Work Order ID 107740

Item Name: Fwd Crosstube

DESIGN	07	DART AEROSPACE LTD	
DRAWN	RF	HAWKESBURY, ONTARIO, CANADA	
CHECKED	07	DRAWING NO.	REV. C
MFG. APPR.	07	D407-667-145	SHEET 3 OF 4
APPROVED	07	TITLE	SCALE
DE APPR.	07	CROSSTUBE ASS'Y (407 HIGH FWD)	NTS
DATE	08.11.06	COPYRIGHT © 2002 BY DART AEROSPACE LTD THIS DOCUMENT IS PRIVATE AND CONFIDENTIAL AND IS SUPPLIED ON THE EXPRESS CONDITION THAT IT IS NOT TO BE USED FOR ANY PURPOSES OR REPRODUCED IN ANY MANNER WITHOUT THE WRITTEN PERMISSION FROM DART AEROSPACE LTD.

DRAWING NO. D407-667-145	TITLE CROSSTUBE ASS'Y (407 HIGH FWD)	REV. C	DART AEROSPACE LTD ENGINEERING ORDER		D.E.O. NO. D407-667-145-C-1	SHEET NO. SHEET 1 OF 1	SCALE NTS
DRAWN 90	CHECKED ASS	MFG. APPR. 18	APPROVED WD		DE APPR. H		
DATE 11.07.15	DATE 11.07.22	DATE 11.07.22	DATE 11/07/22		DATE 11.07.21

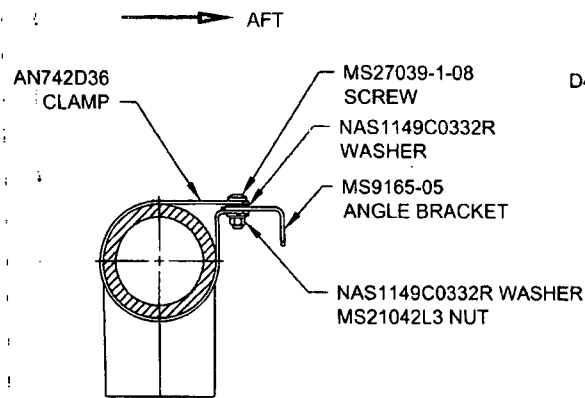
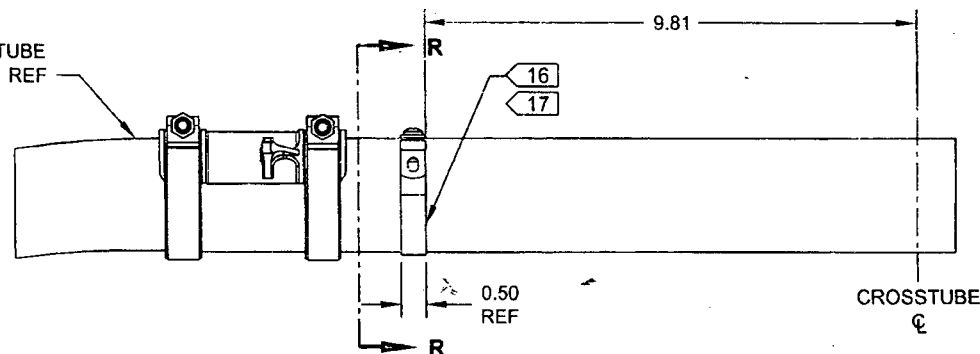
ADD ELECTRICAL GROUNDING STRAP

ITEM	QTY -145	PART NUMBER	DESCRIPTION
1	X	D407-667-145	CROSSTUBE ASSEMBLY (407 HIGH FWD)
10	2	AN742D36	CLAMP
11	2	MS9165-05	ANGLE BRACKET
12	2	MS21042L3	NUT (OR MS21042-3)
13	2	MS27039-1-08	SCREW
14	4	NAS1149C0332R	WASHER (OR AN960C10L)
